**Bybee Station & Bus Stop**  
**Discussion with Eastmoreland, Sellwood-Moreland and Reed Neighborhoods**  
**January 28, 2010**  
**Eastmoreland Golf Course**

## Bybee Station -- Bus Stop Options

**PORTLAND TO MILWAUKIE LRT**  
**SEGMENT C**  
 BYBEE STATION  
 SITE PLAN

# AM peak WB Traffic Queue Lengths at the Bus stop with Maximum (Lift) and Average Dwell Times.

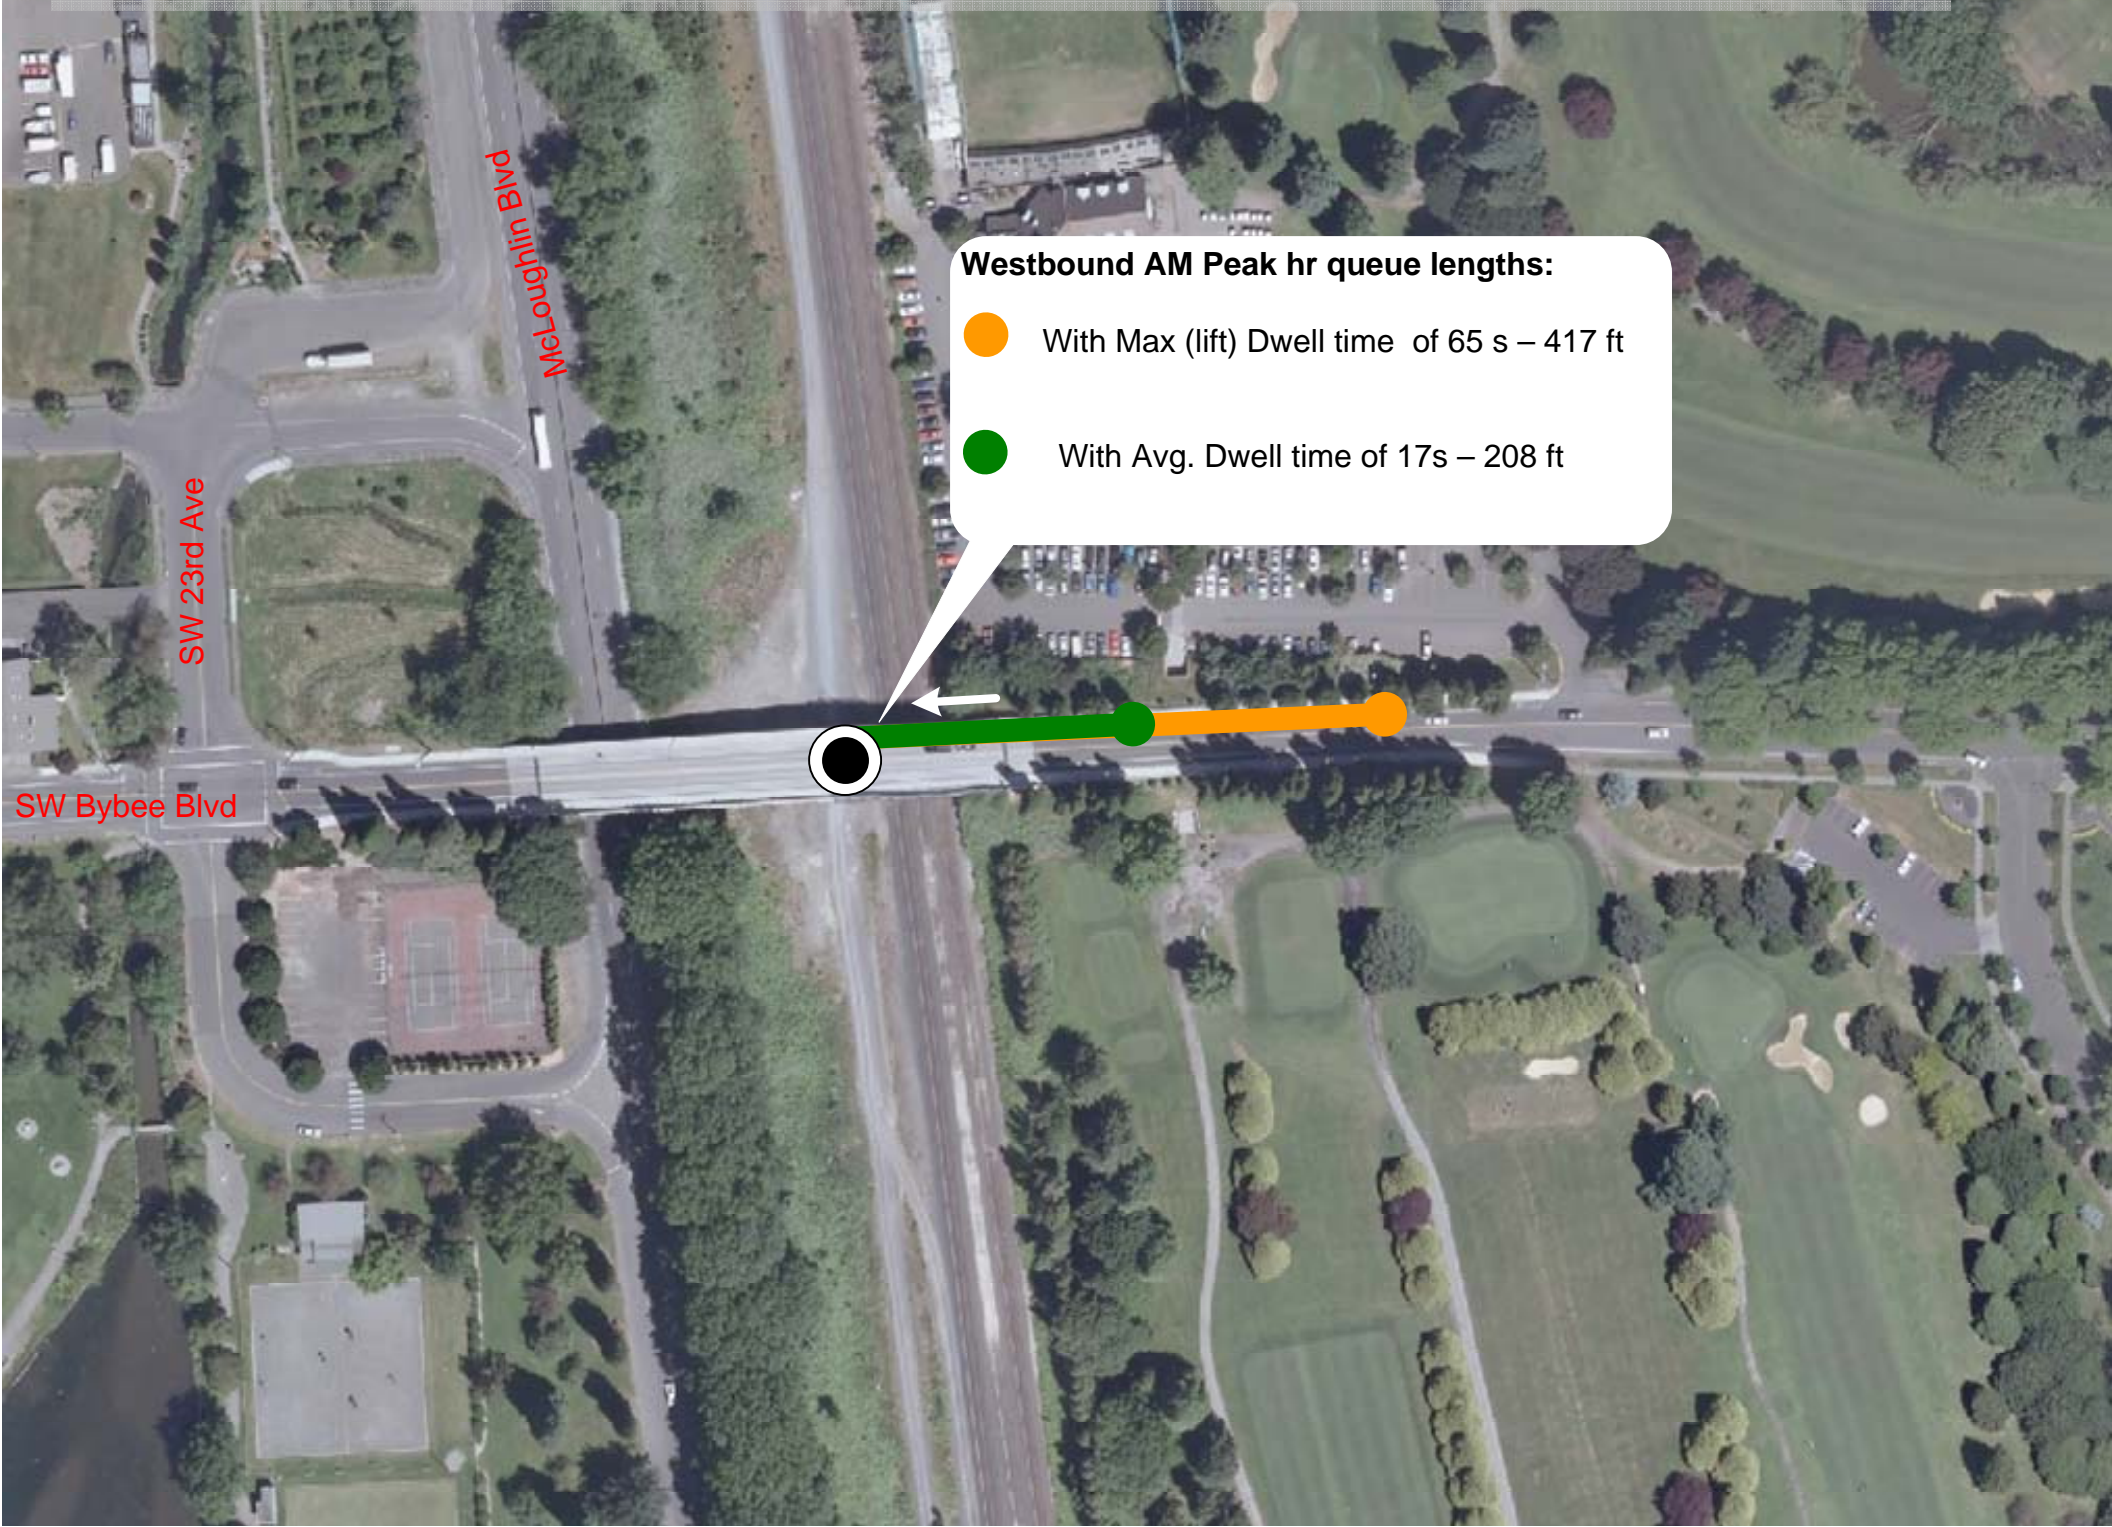
- There are already safety concerns with the vertical curve of the existing bridge.
- Data provided for queue lengths from bus dwell time seems incorrect.

# Abutment-to-Abutment

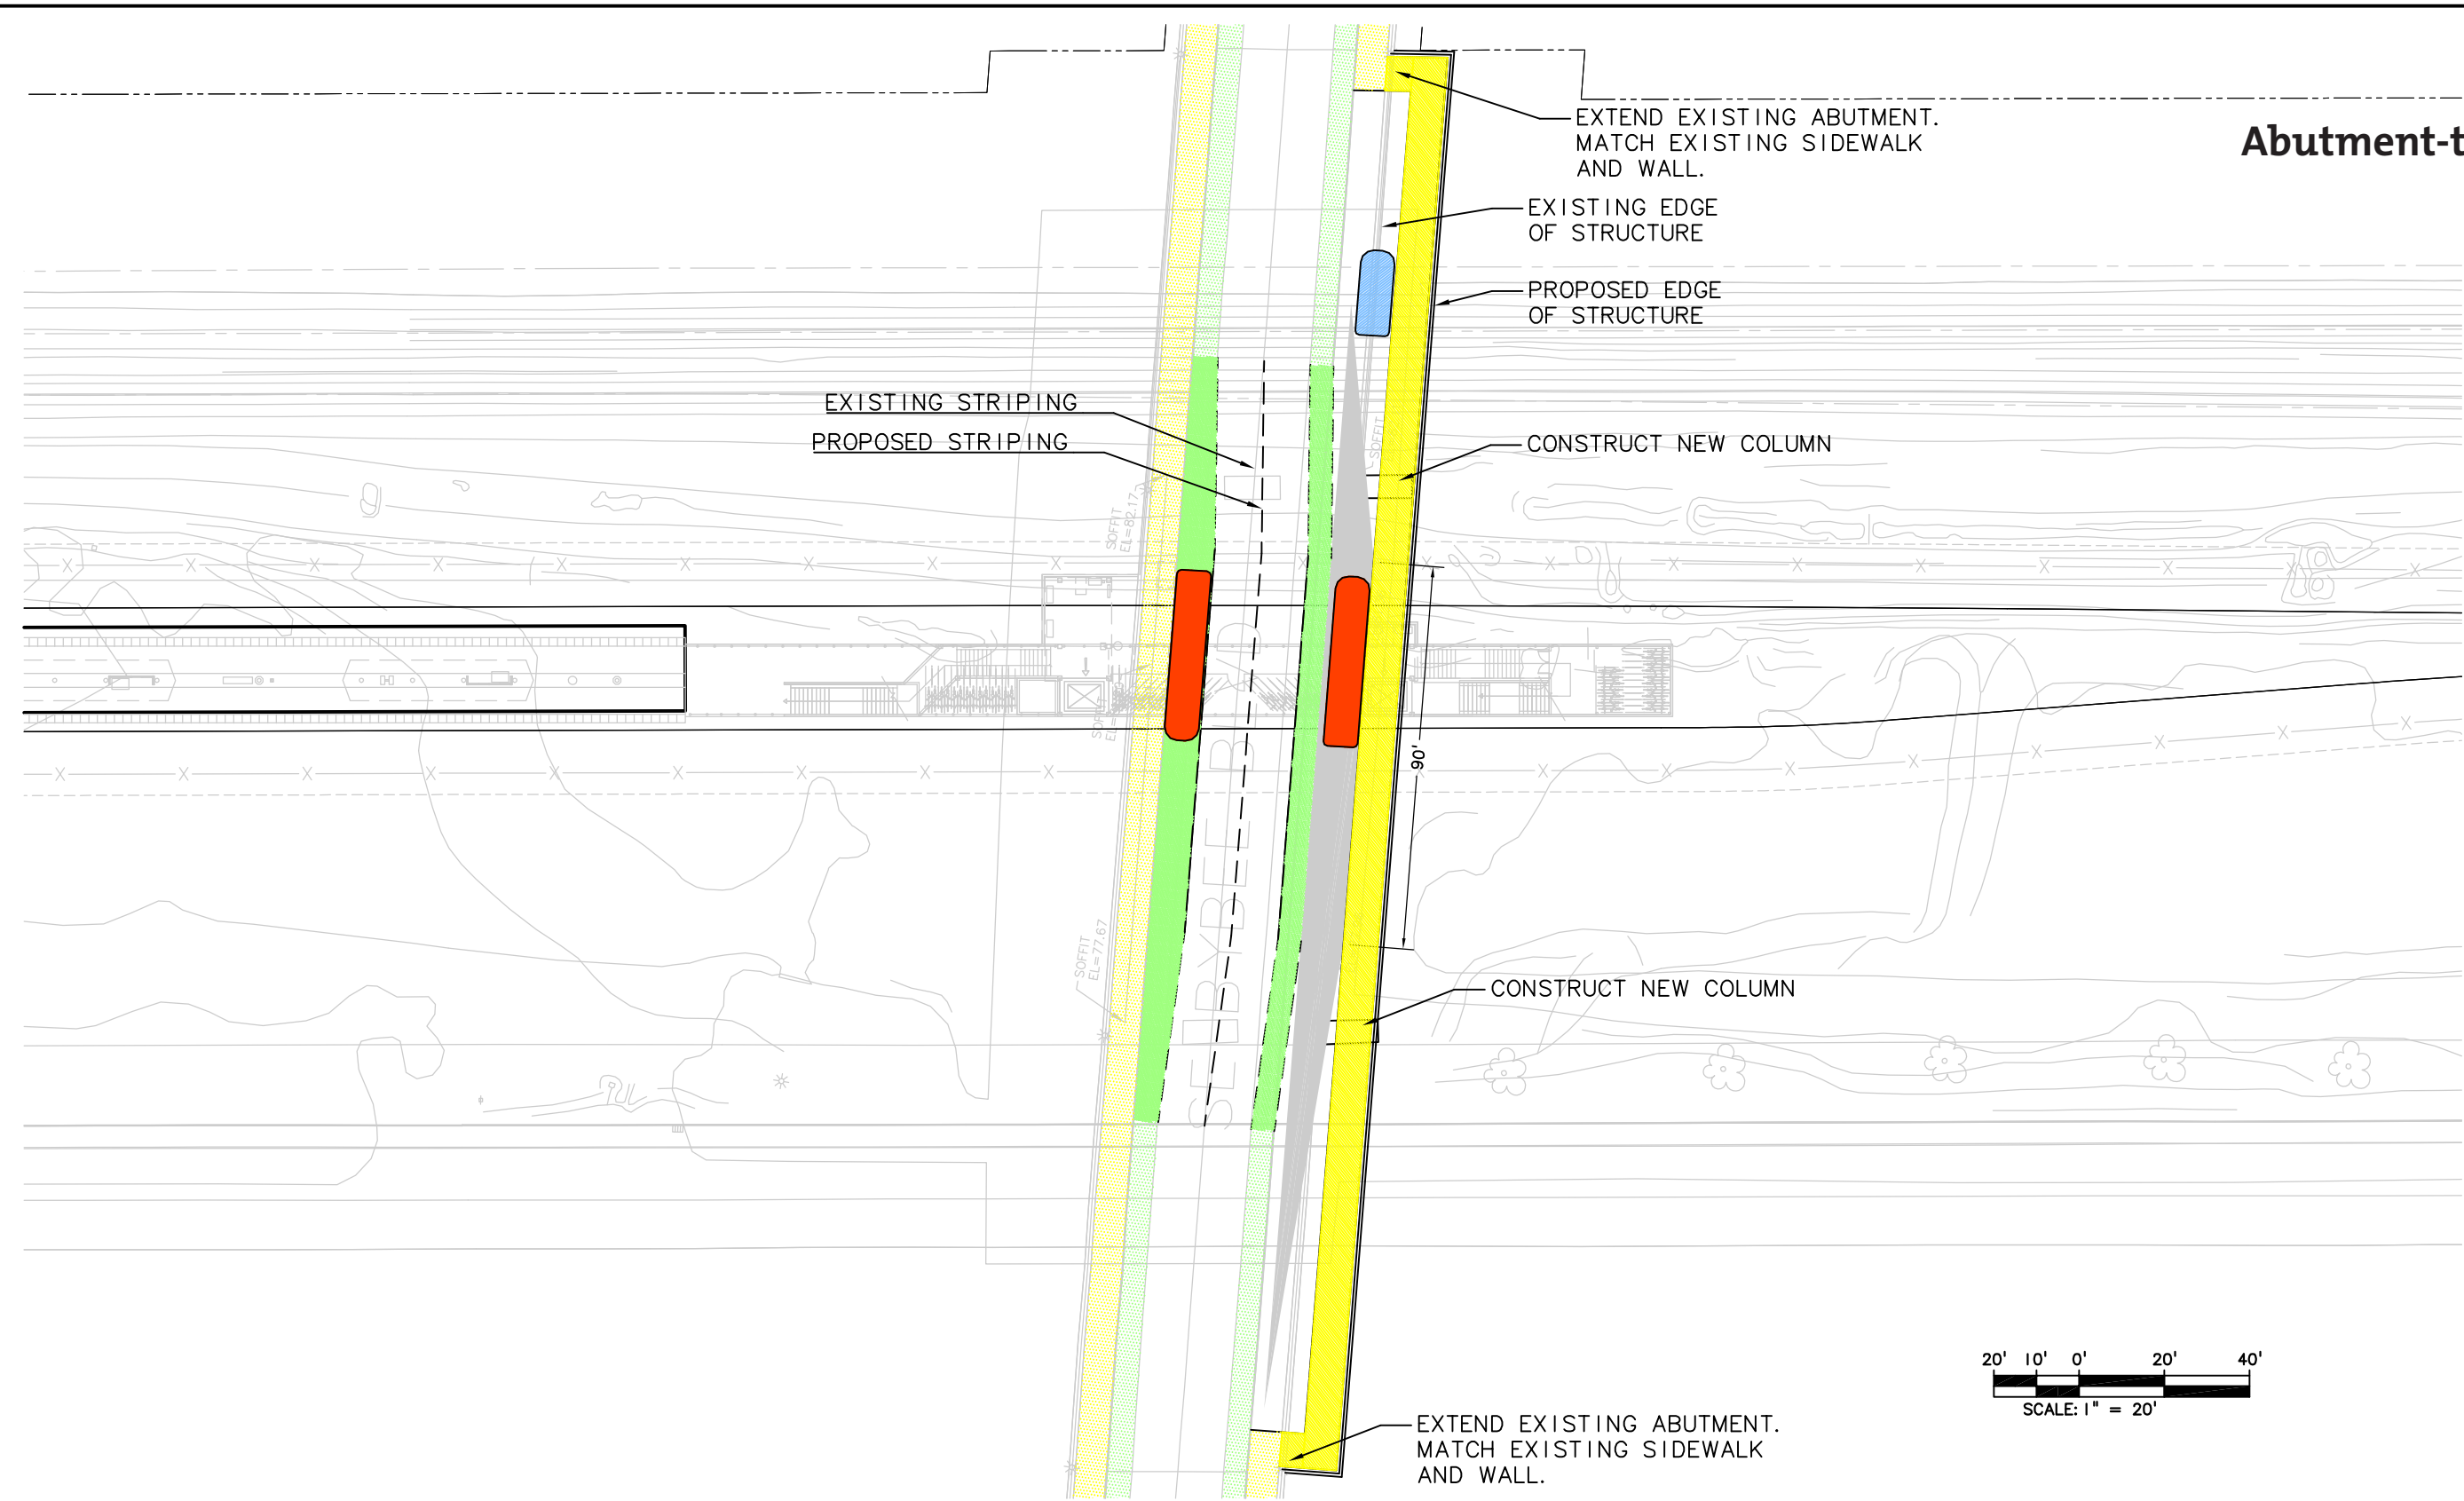
- If there are any bus stops on the bridge, they should not block auto travel lanes.
- No specific preference on pier-to-pier versus abutment-to-abutment structure, as long as it keeps stopped buses out of auto travel lane and includes finishes that match existing.
- Design should minimize potential conflicts among buses, autos and cyclists.

- Build pier-to-pier pullouts on both sides of the bridge to maintain symmetry.
- Need to plan for safe Quick Drop area. Concerns about motorists crossing bike lane on the bridge to drop off/pick up.
